Castle Aggregate

Re: Amendment 5, Permit Number M1986-015 Response to the Adequacy Review No. 2,
February 22, 2021

RE: Adequacy Review No. 2; 112c Construction Materials Amendment Application (AM-05), Pueblo East, Permit No. M-1986-015

EXHIBIT B-1

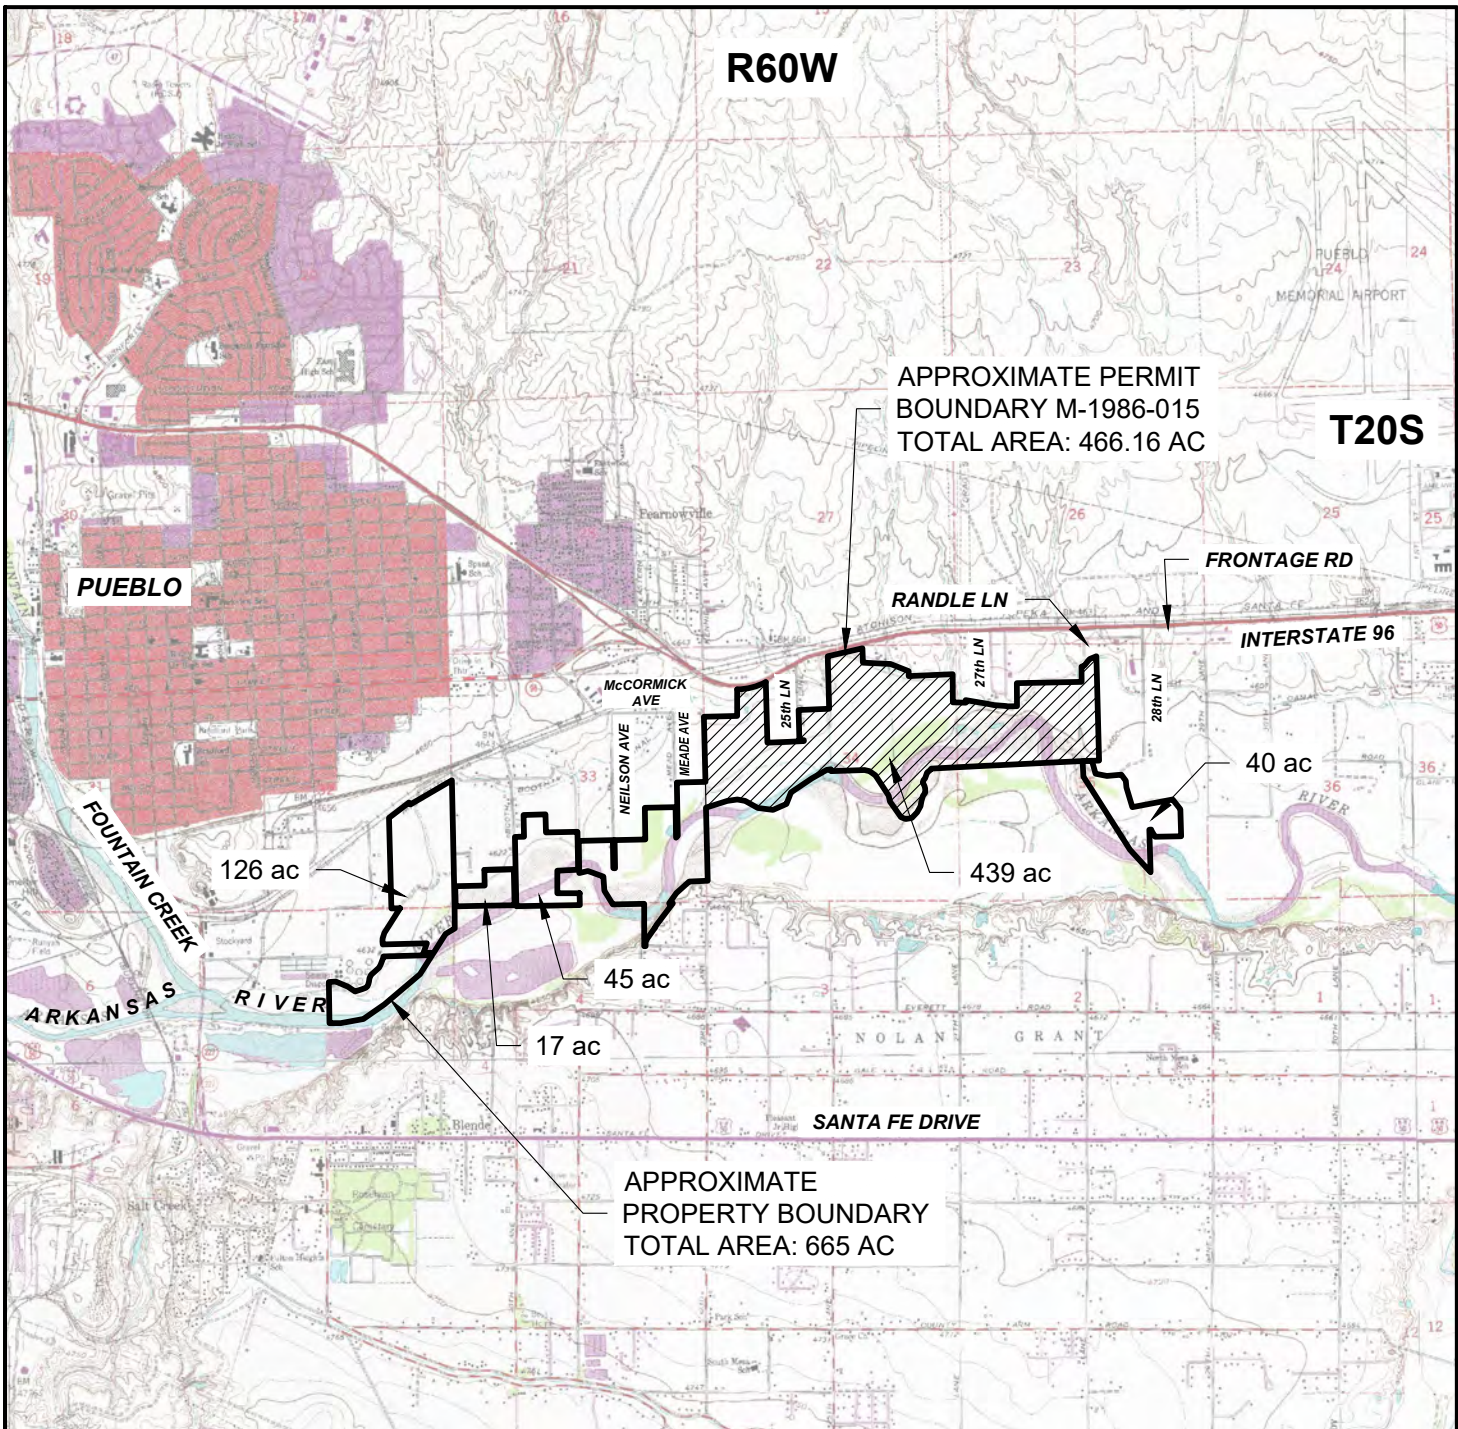
2. Please provide an updated Index Map that depicts the current approved permit boundary along with acreage. The map provided does not reflect acreage that was added to the permit in AM-01 to the southeast and the 28 acres that was added with the approval of AM-04 south of the Arkansas River. Attached to this review are the permit boundary maps from the four Amendments to help the operator.

Index Map has been corrected to include the Property Boundary lands south of the Arkansas River. Total Acres are now 466.16 acres.

EXHIBIT F-1
RECLAMATION PLAN

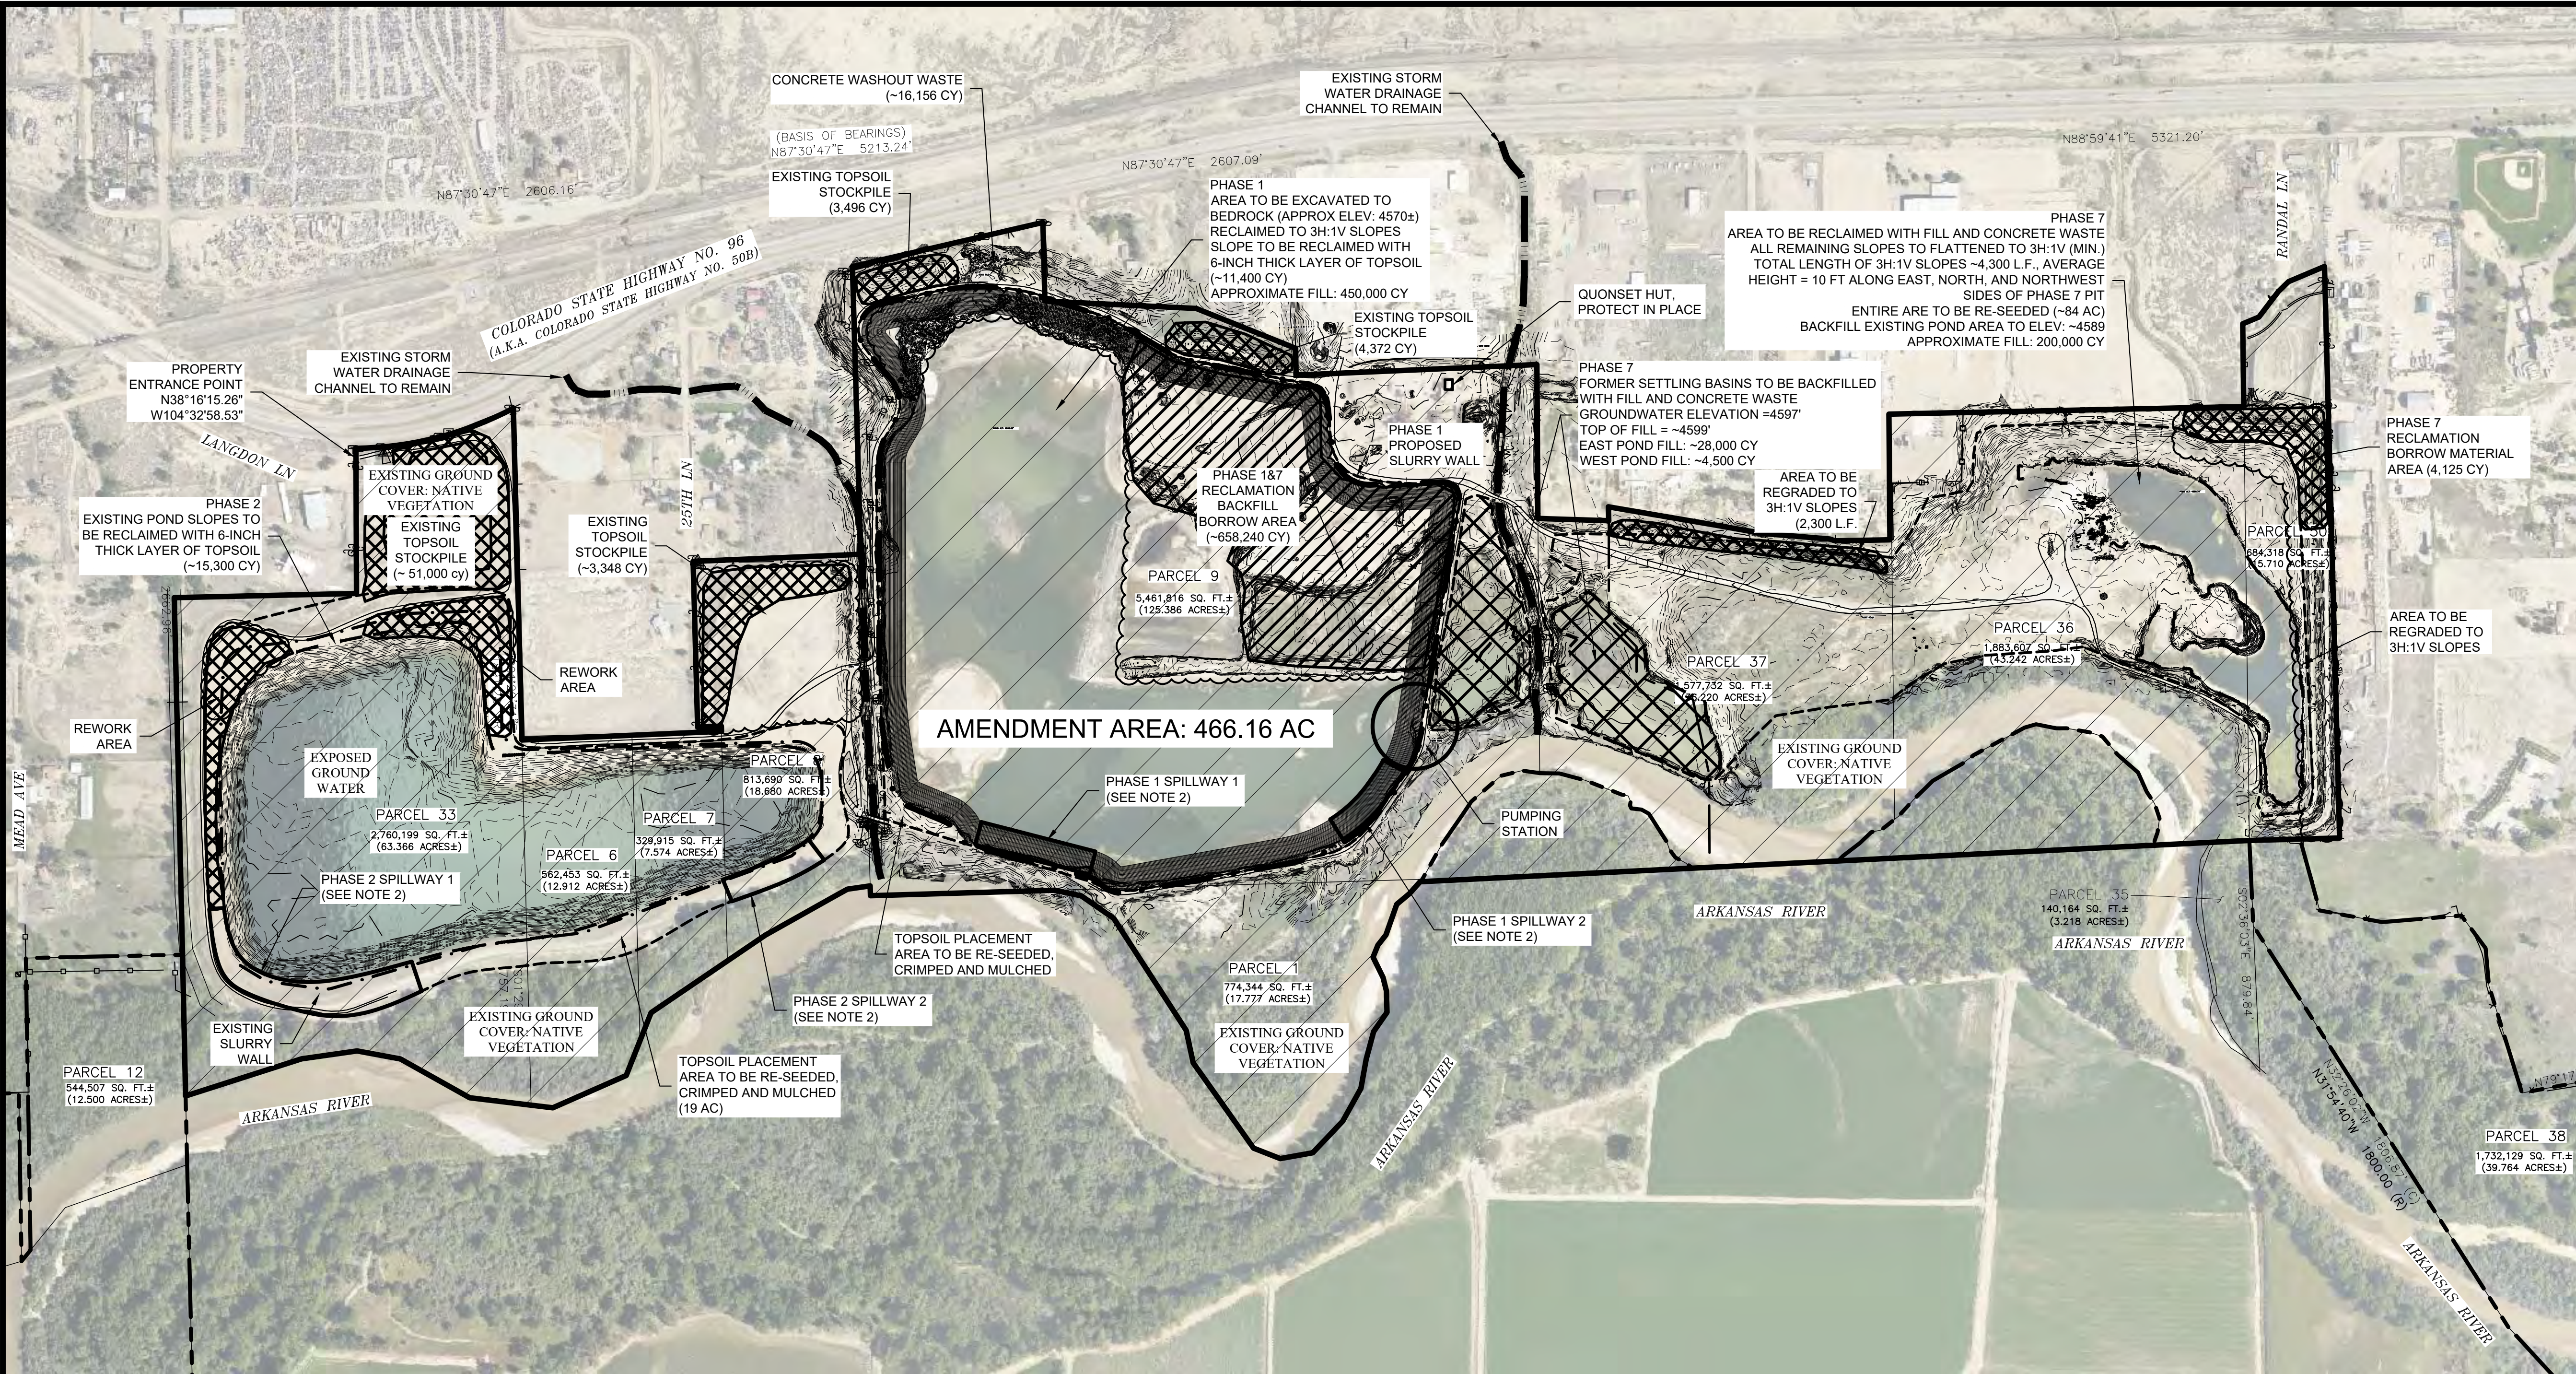
12. Please clearly show on the Reclamation Plan Map the location of the Quonset hut to remain after reclamation is complete.

13. Please clearly show on the Reclamation Plan Map the 12 acre area that will be excavated for the ~660,000 cys of material.

14. In reply to question #21 of the Preliminary Adequacy Review (PAR) the operator stated there are 6 topsoil stockpiles across the site. However only 5 stockpiles are identified, 2 piles in Phase 1, 2 piles in Phase 2 and 1 pile in Phase 7. A review of the Reclamation Plan Map shows there are 3 piles in Phase 2 with quantities noted, none called out in Phase 1, and 1 pile identified but missing volume estimate. Please clearly identify all topsoil stockpiles at the site along with the estimate volumes of the piles.

The map has been adjusted to include the location of the Quonset Hut in Phase 1. Coordinates of each corner:

Map F-1 has been modified to show the 12 acre site that will be used for the primary fill in Phase 1.

Correction: There are only 5 stockpiles of topsoil.
